UPDATE TO FIG. 4-9. VALUE IN NOTES 1 & 2 SLIGHTLY MODIFIED ( $V_{dropout}$  and  $R2$ ). NOTE 3 ADDED.

X3TY.2 / 89-004 R2

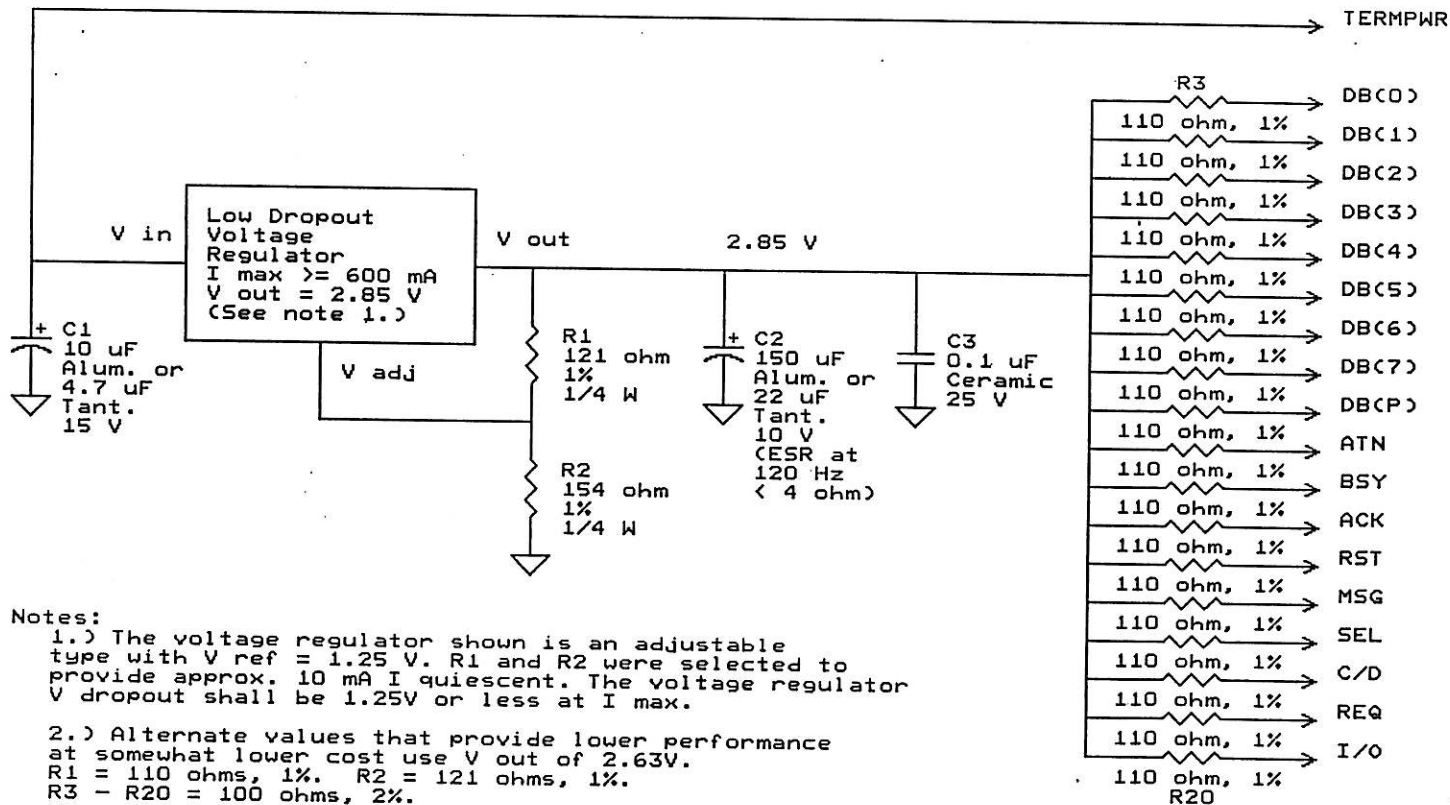
1.) The voltage regulator shown is an adjustable type with  $V_{ref} = 1.25 \text{ V}$ .  $R1$  and  $R2$  were selected to provide approx. 10 mA  $I_{quiescent}$ . The voltage regulator  $V_{dropout}$  shall be 1.25V or less at  $I_{max}$ .

2.) Alternate values that provide lower performance at somewhat lower cost use  $V_{out}$  of 2.63V.  
 $R1 = 110 \text{ ohms, 1%}$ .  $R2 = 121 \text{ ohms, 1%}$ .  
 $R3 - R20 = 100 \text{ ohms, 2%}$ .

3.) Increasing the value of  $C2$  to 47uF will decrease the noise on terminated lines by 5-7%.
